January 12, 2023 Planning Commission Meeting

701 Fayette Street Land Development Application

BOROUGH OF CONSHOHOCKEN
MONTGOMERY COUNTY, PENNSYLVANIA

APPLICATION FOR SUBDIVISION/ LAND DEVELOPMENT

GRADING/IMPROVEMENTS PLAN

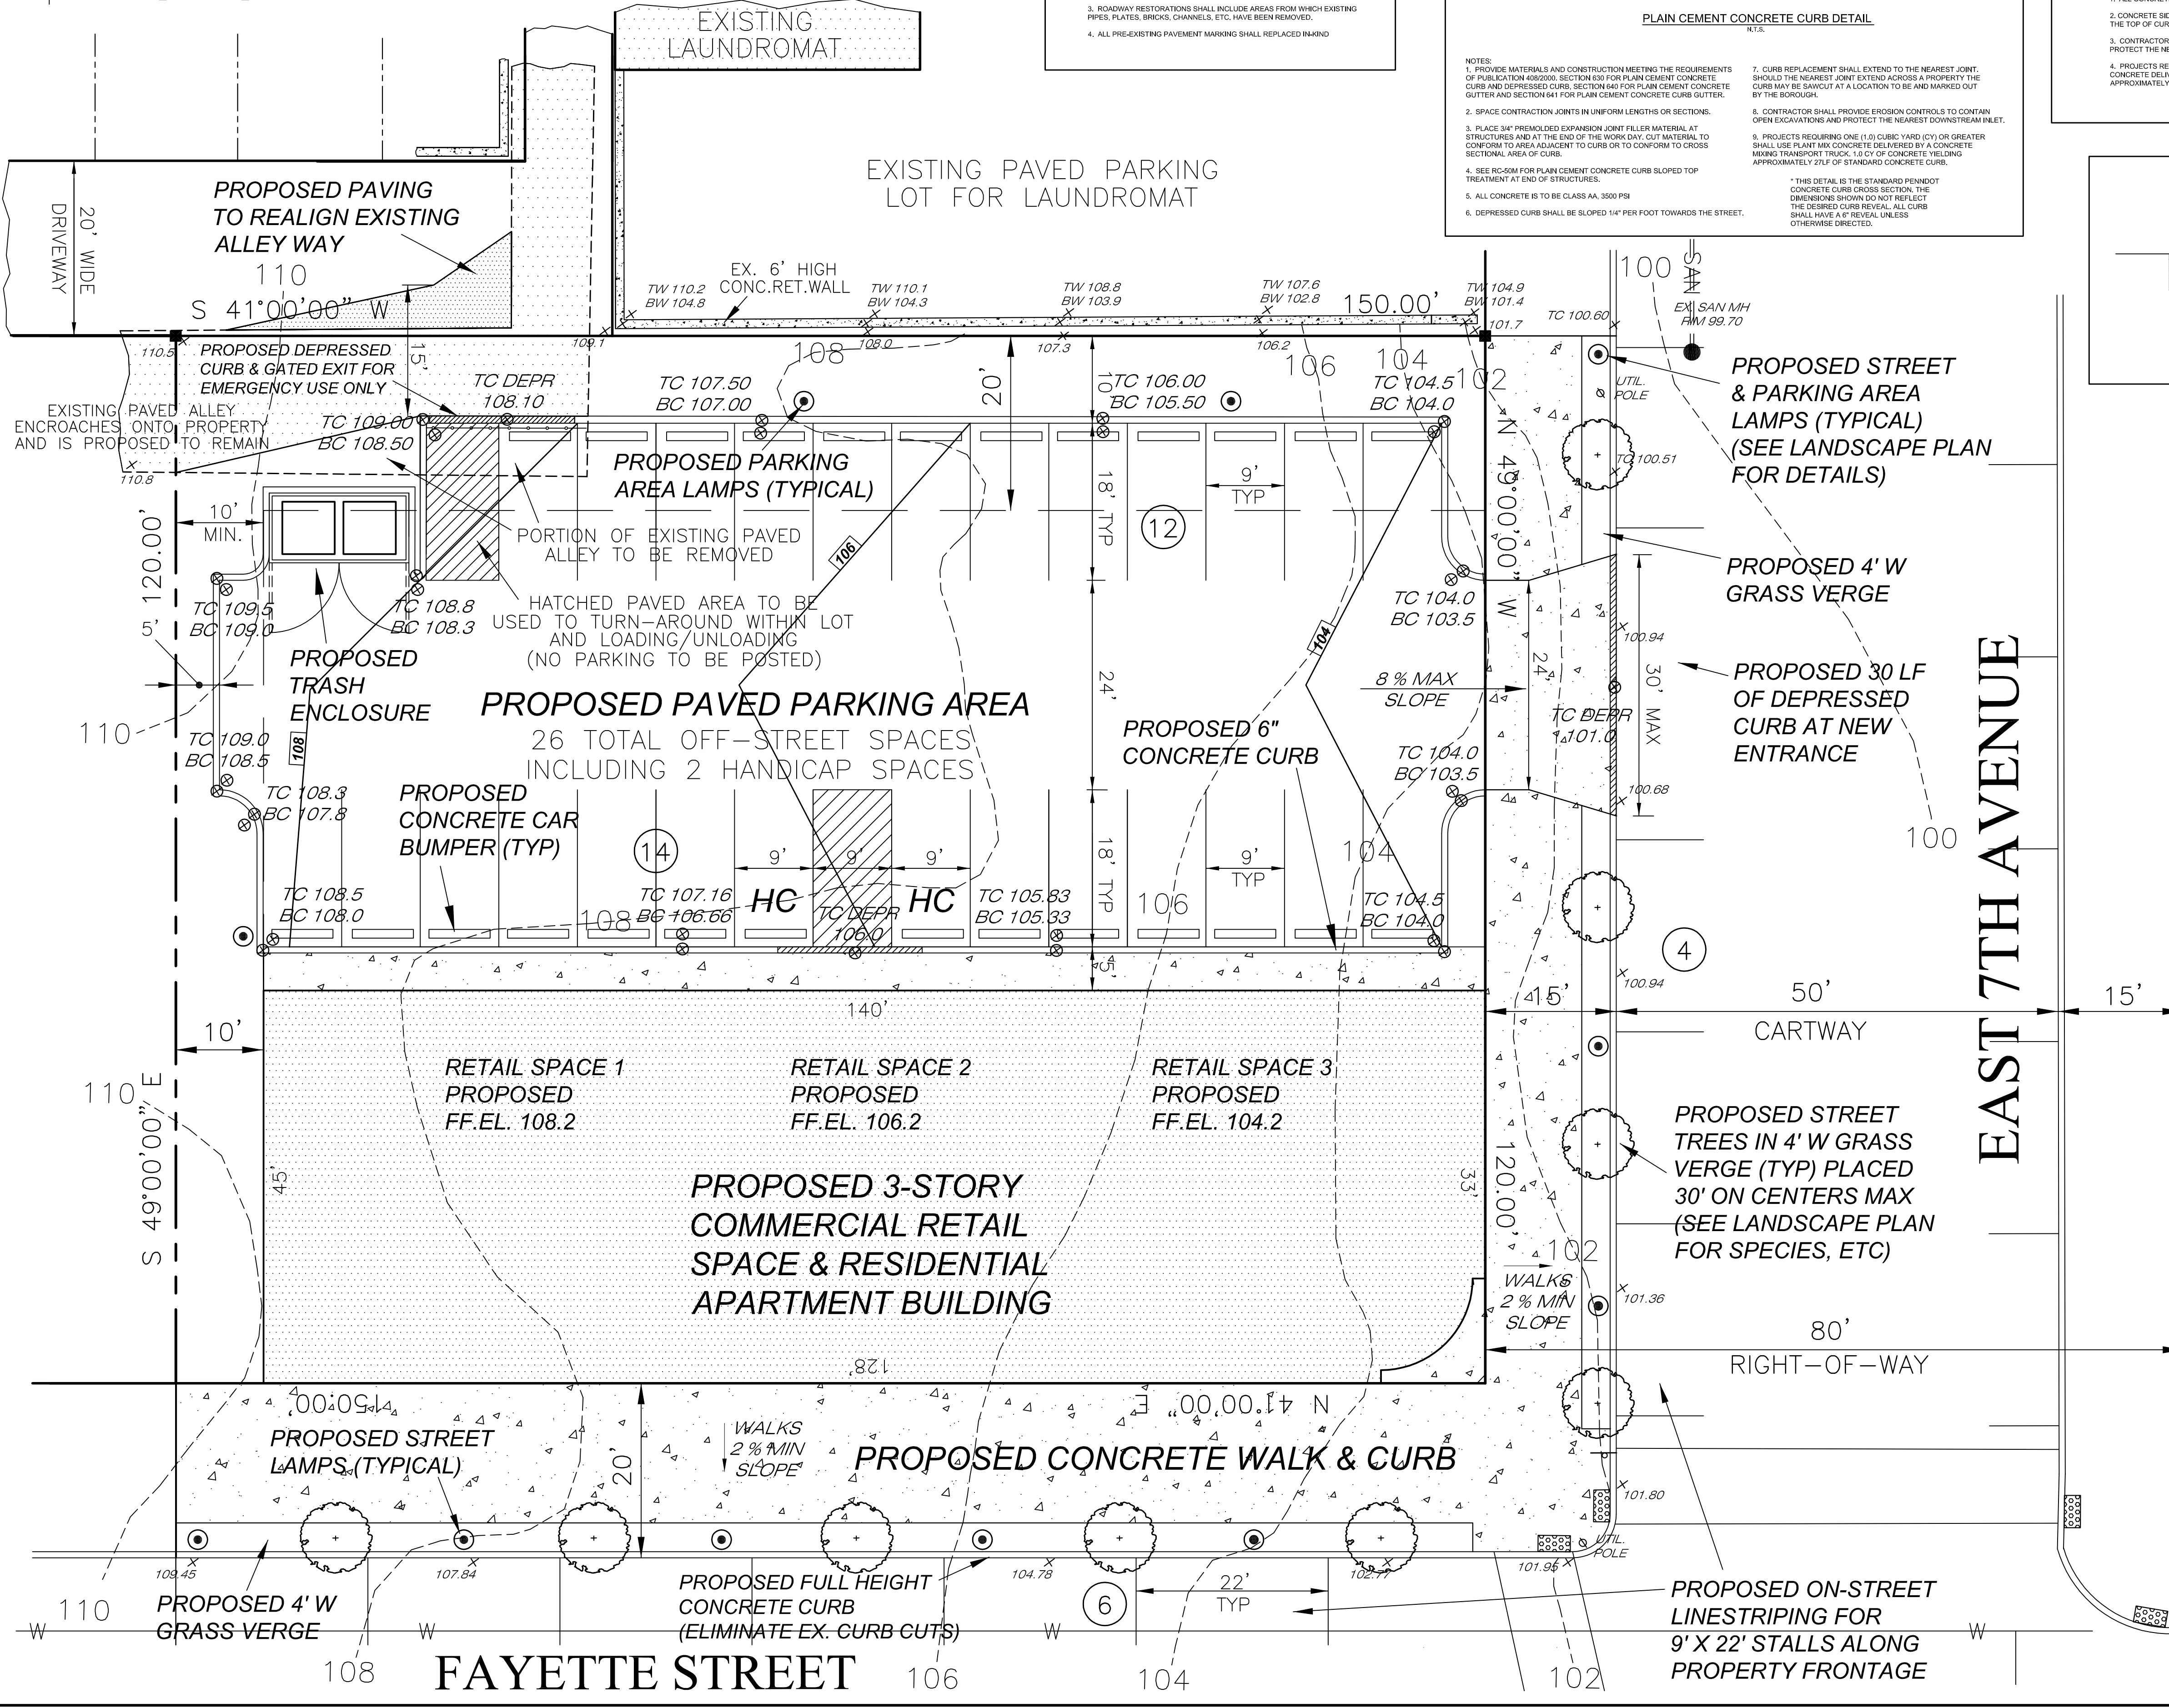
4. We have the following comments related to details:
 - a. The width dimensions included in the Cement Concrete Pads & Sidewalk Detail on the Grading/Improvements Plan, Sheet 2, shall be clarified since they do not match plan views.

The proposed parking area lamp locations are shown on the Grading/Improvements Plan (sheet 2); however, no illumination levels have been provided for these parking lights. The lighting plan shall be updated to show the point-by-point illumination level calculations to ensure the on-site lighting is compliant with the provisions of this Code Section.

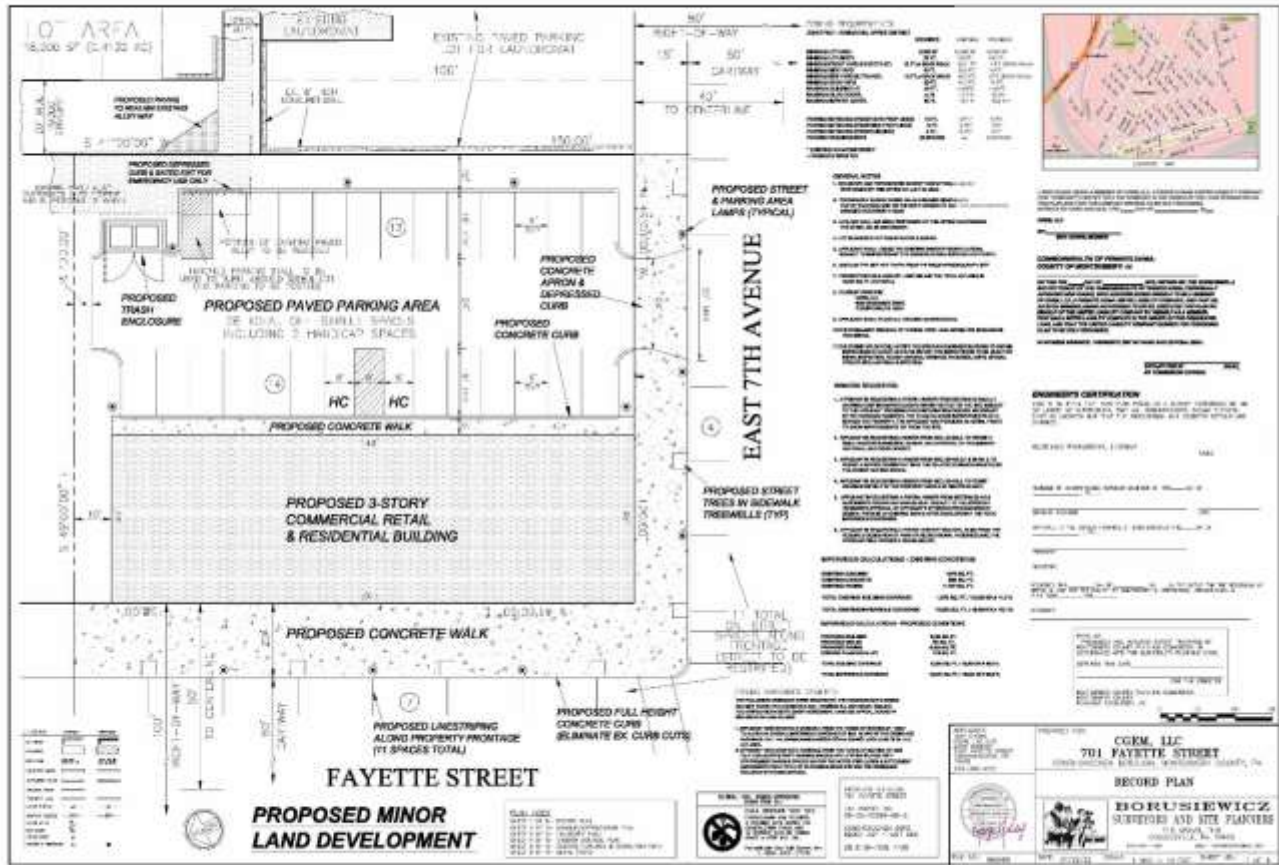
Recommend a continuous soil planting area of 5-6 ft. wide for effective tree growth & health instead of confining street trees to small 3 ft. by 3 ft. tree wells.
